<b>DOCKETED</b>	
<b>Docket Number:</b>	23-OPT-01
<b>Project Title:</b>	Fountain Wind Project
<b>TN #:</b>	248330-2
<b>Document Title:</b>	Project Refinement Memo September 2021
<b>Description:</b>	N/A
<b>Filer:</b>	Caitlin Barns
<b>Organization:</b>	Stantec Consulting Services, Inc.
<b>Submitter Role:</b>	Applicant Consultant
<b>Submission Date:</b>	1/5/2023 10:09:40 AM
<b>Docketed Date:</b>	1/5/2023

To:	Shasta County Planning Department and Board of Supervisors	From:	Stantec Environmental Services
File:	Fountain Wind Project	Date:	September 24, 2021

**Reference: Analyses of Refinements to the Proposed Project Design Since Circulation of the Final Environmental Impact Report**

**Title**  
**Updated Impacts to Aquatic Resources - Refined Project Layout**

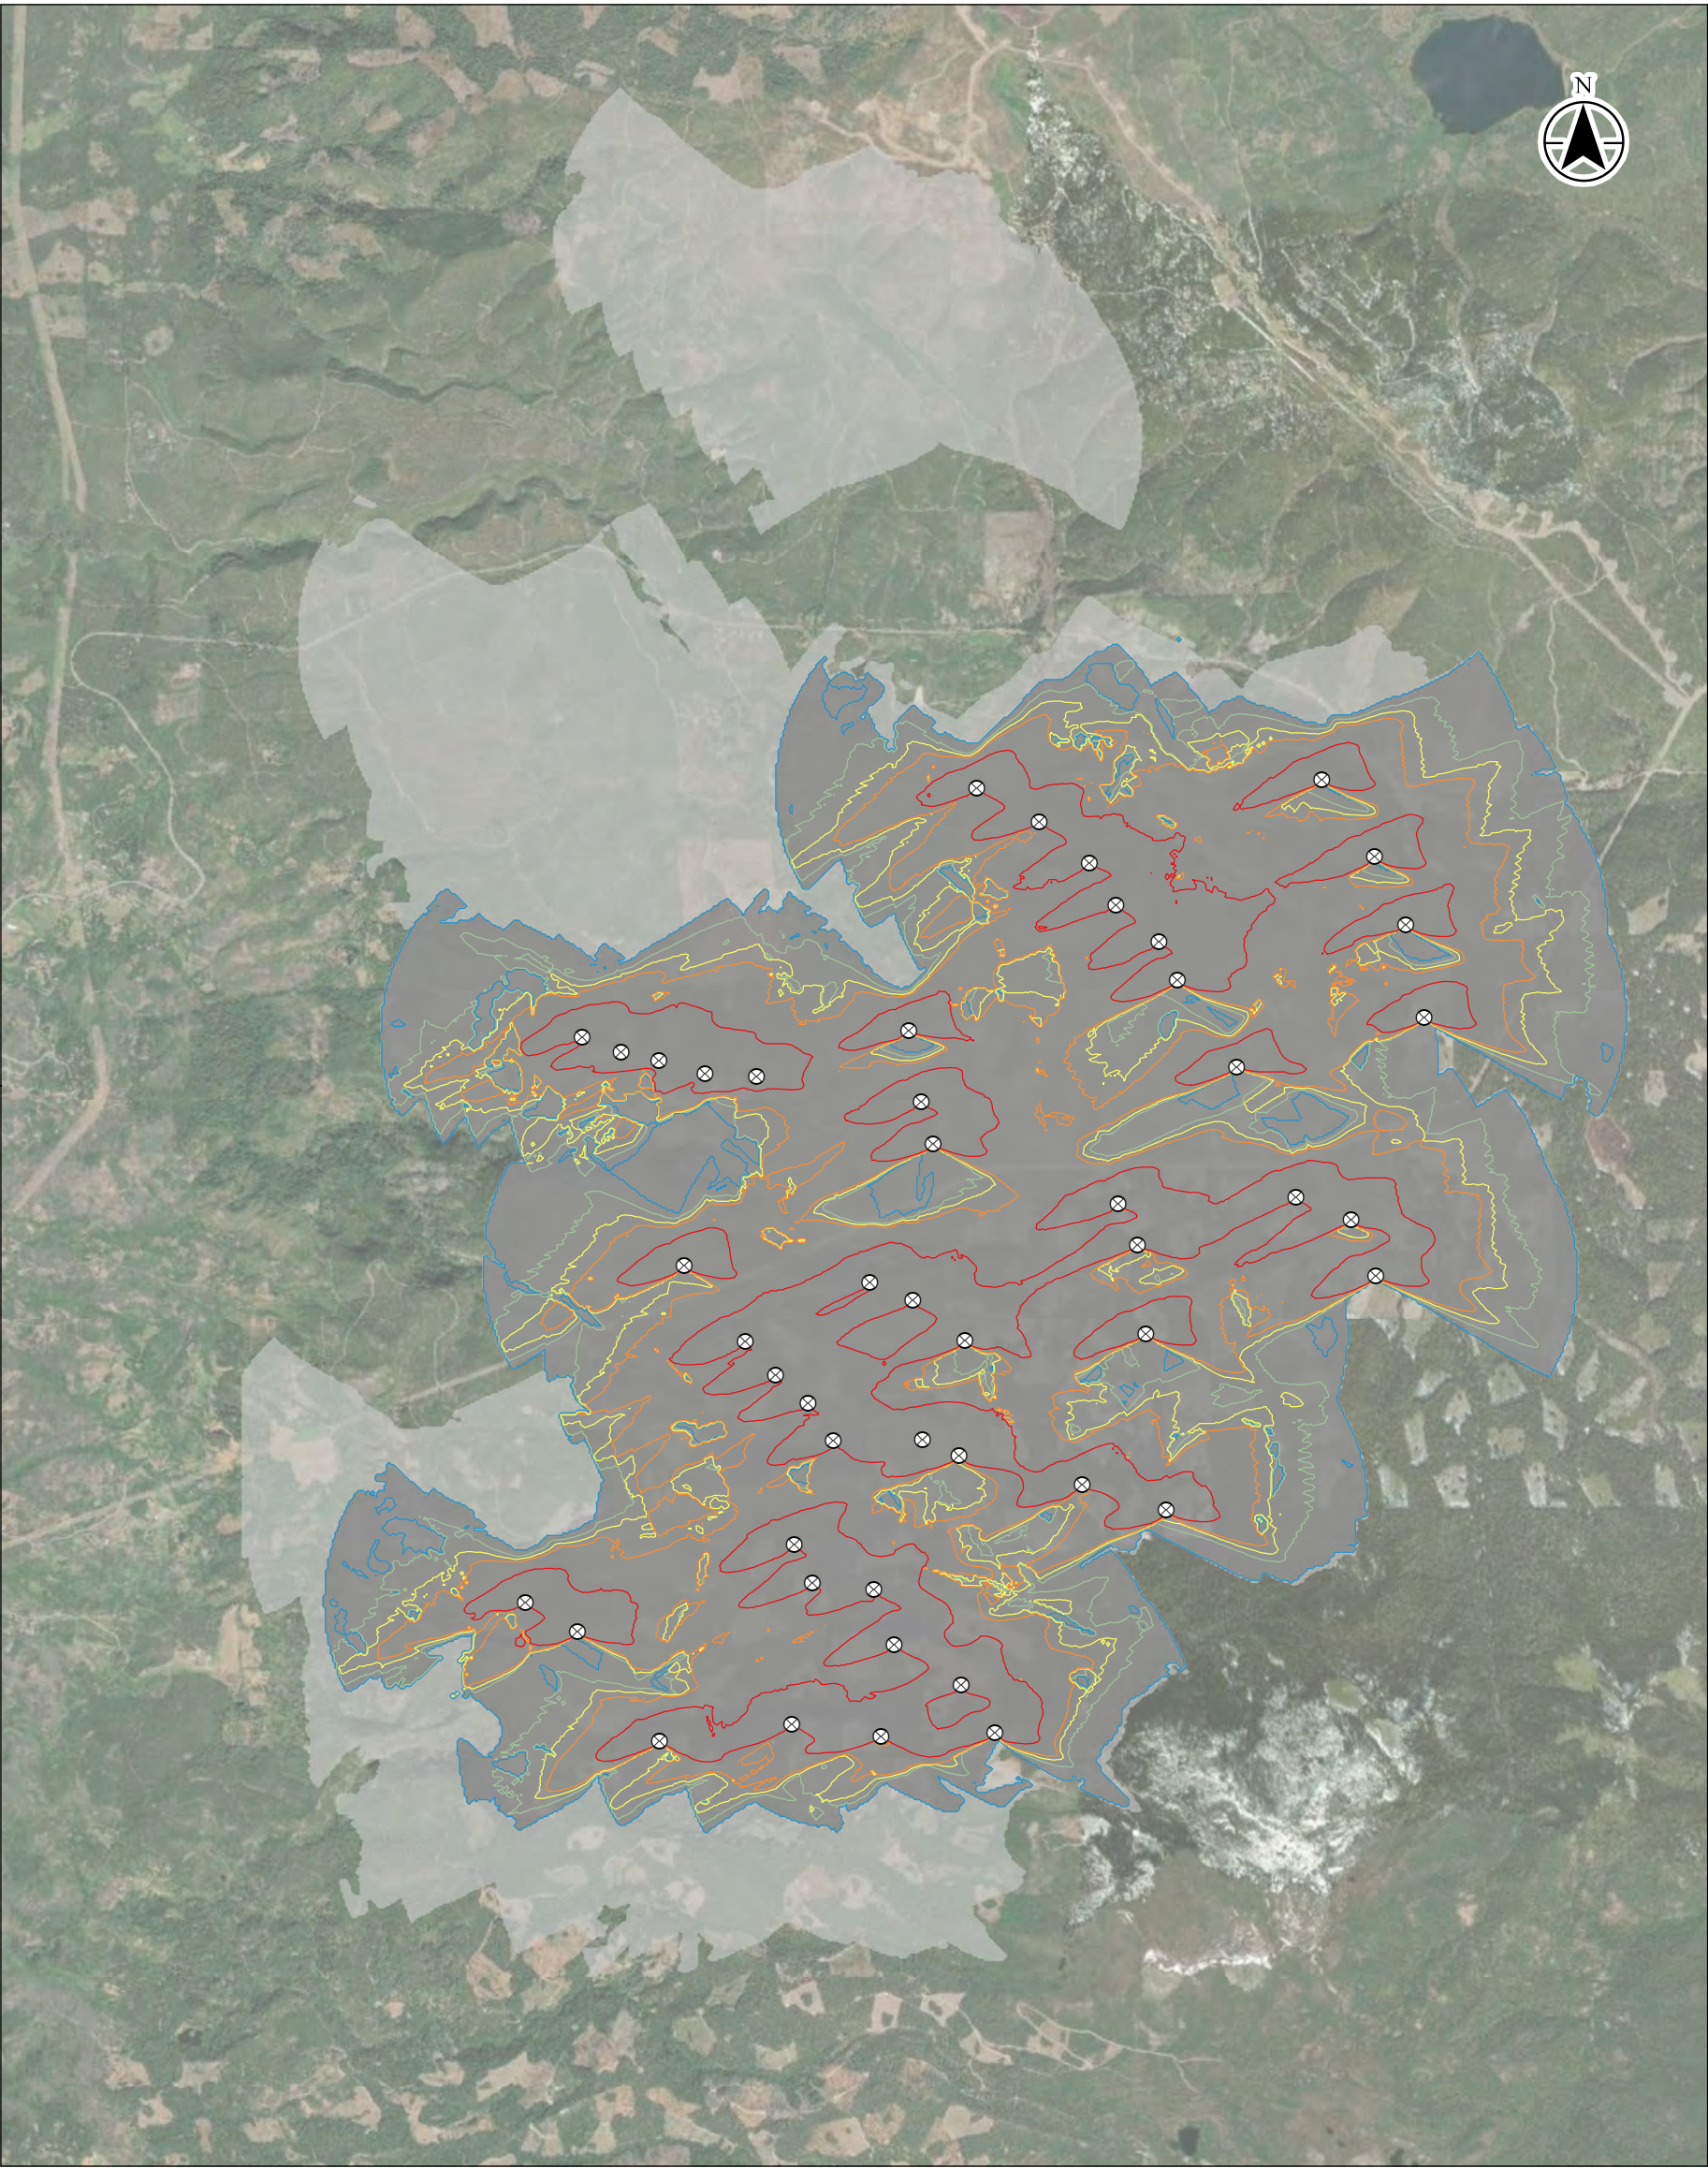
No additional acreage or different wetland or aquatic features would be impacted by construction of the refined project. Total permanent impacts to wetlands and other waters would be reduced by 53%. Total temporary impacts to wetlands and other waters would be reduced by 49%. (Table 2). With implementation of Alternative 1, the elimination of turbines north of SR 299, direct and indirect impacts to Richardson Creek and Little Hatchet Creek would be eliminated.

Comparison of Shadow Flicker Results  
(2020 vs 2021)

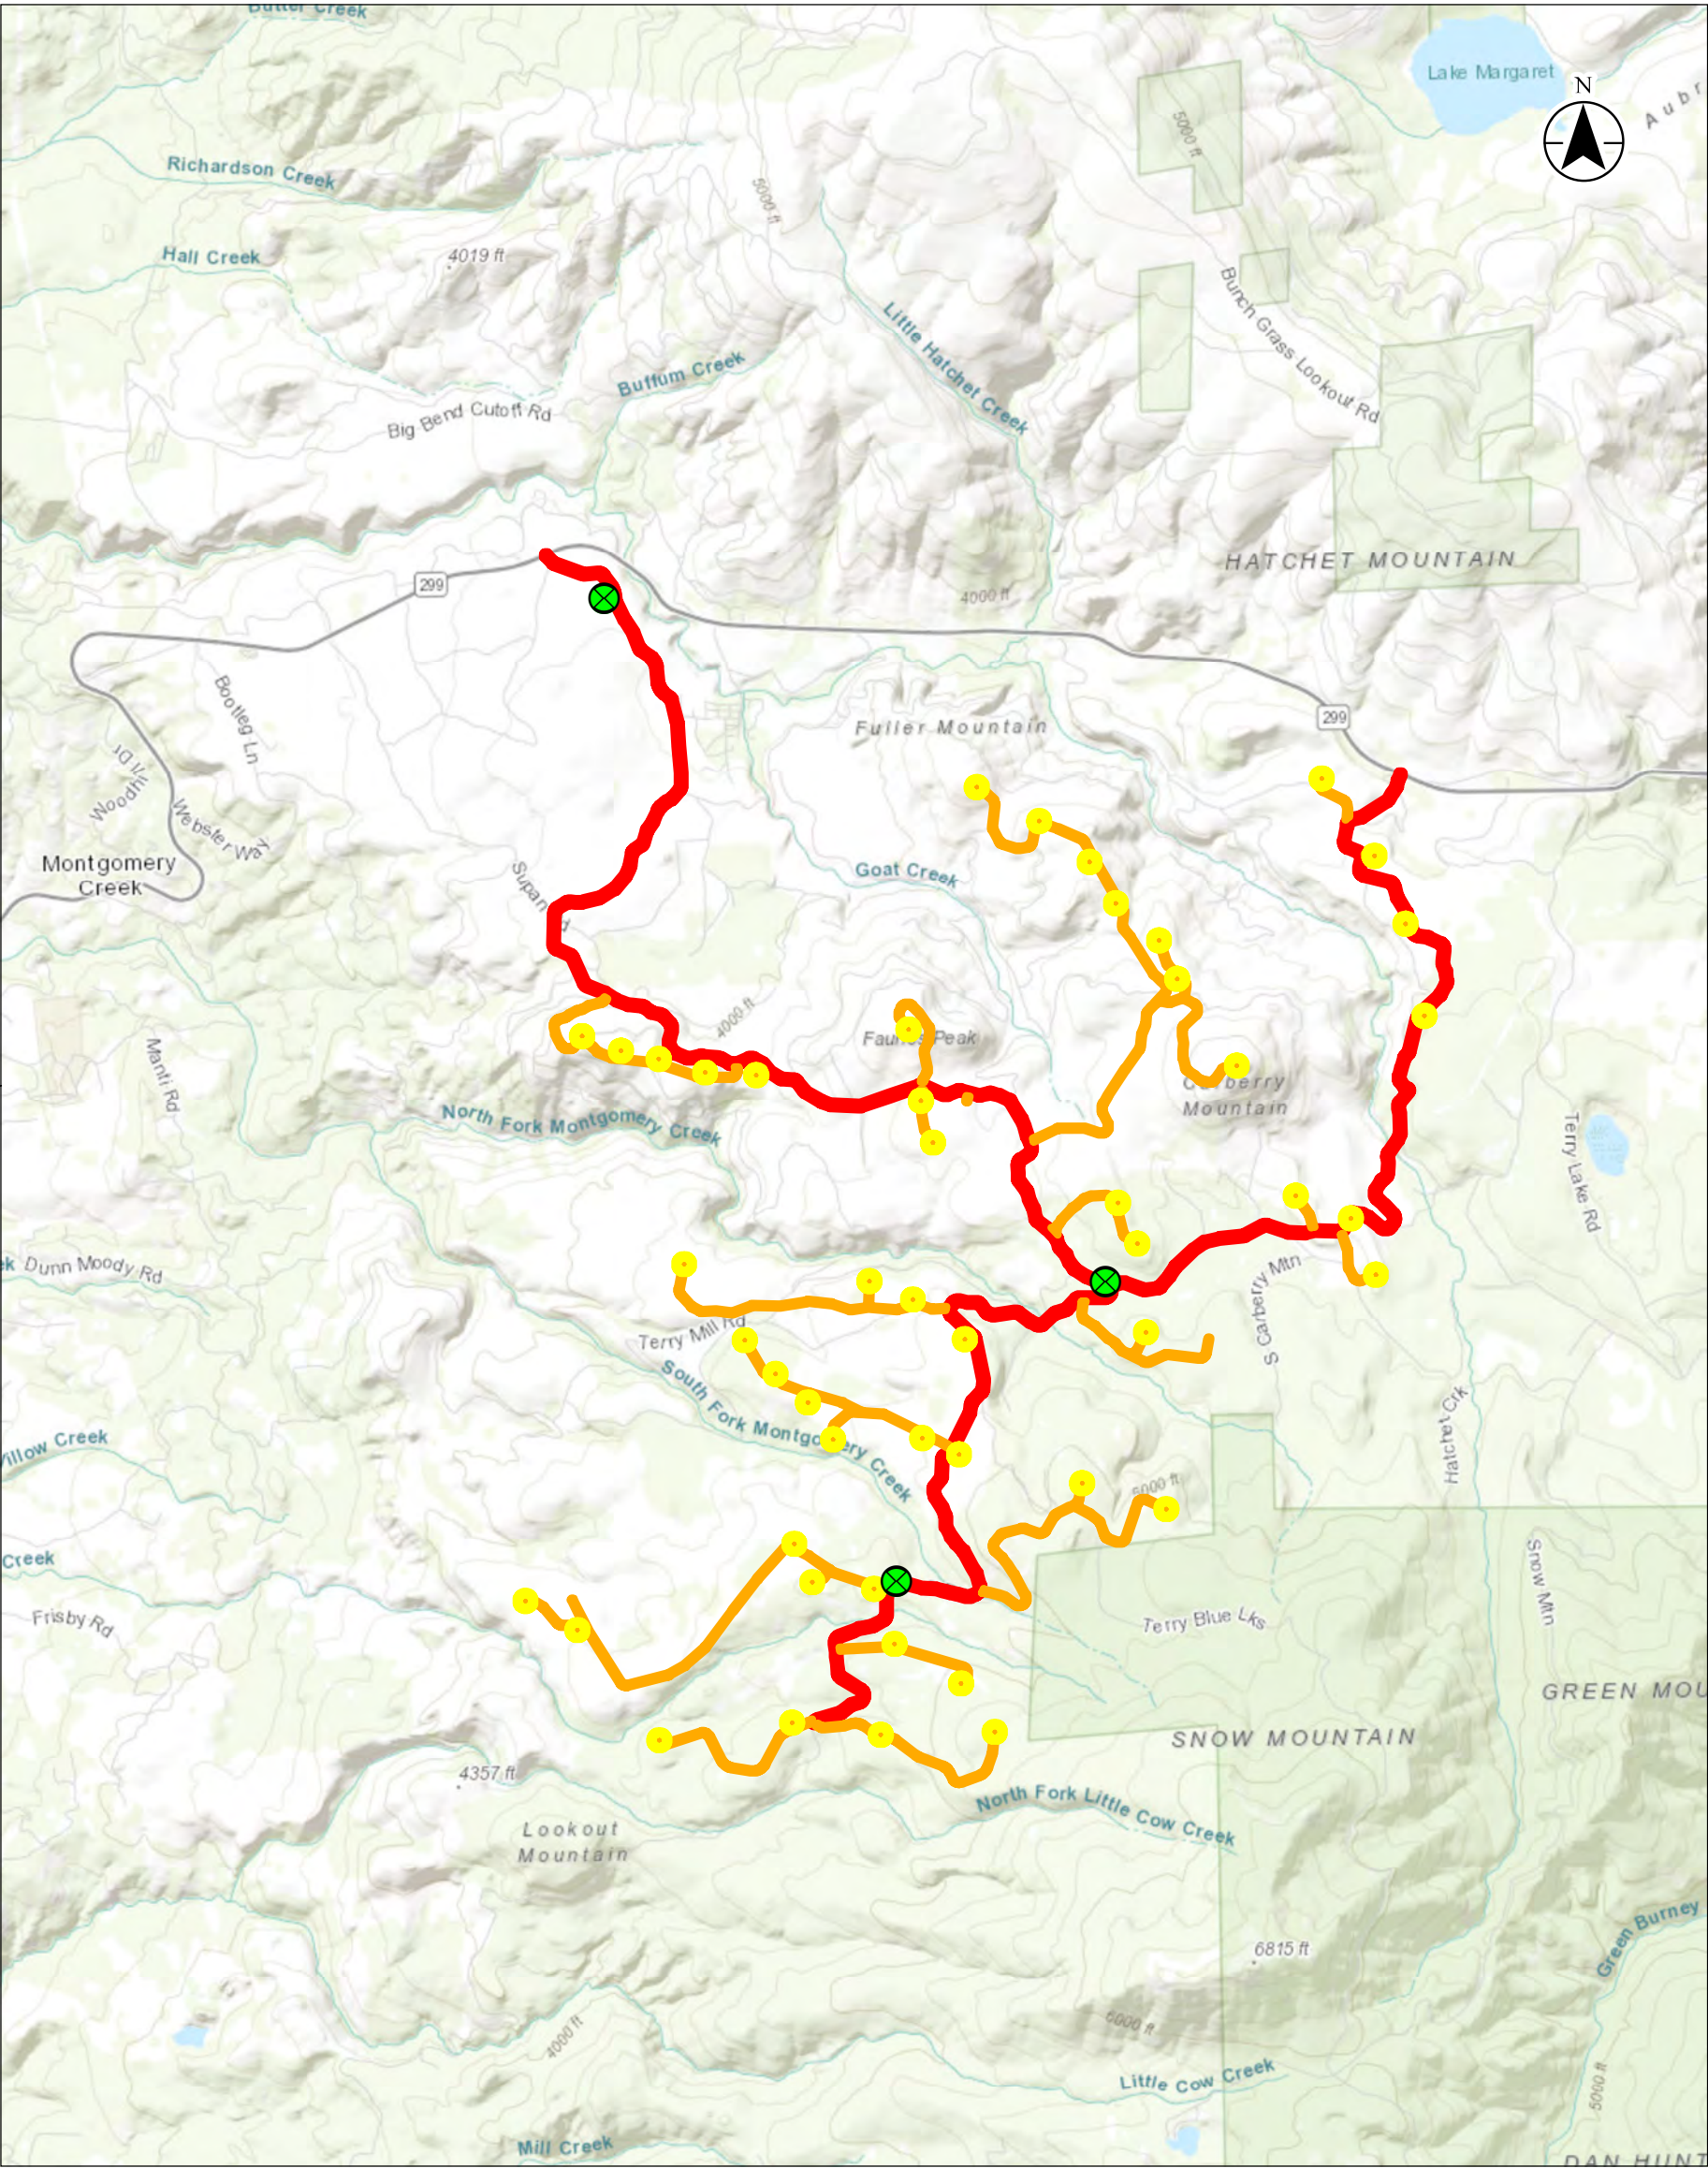
A shadow flicker study was performed on the refined project footprint (Appendix B). Results of modeling indicated that the refined project would significantly reduce shadow flicker at nearby receptors. The shadow flicker analysis presented in the Draft and Final EIR concluded that 40 receptors would receive between 0 and 30 hours of shadow flicker per year, and 18 receptors would receive more than 30 hours of shadow flicker per year (EDR 2020) (Table 4, Figure 3). With the refined project, only one receptor would receive more than 30 hours of shadow flicker per year. This one receptor is a project participant, i.e., a resident who will benefit economically from the project. A common finding is that annoyance from shadow flicker is lower among residents who benefit economically from wind turbines (EDR 2021).
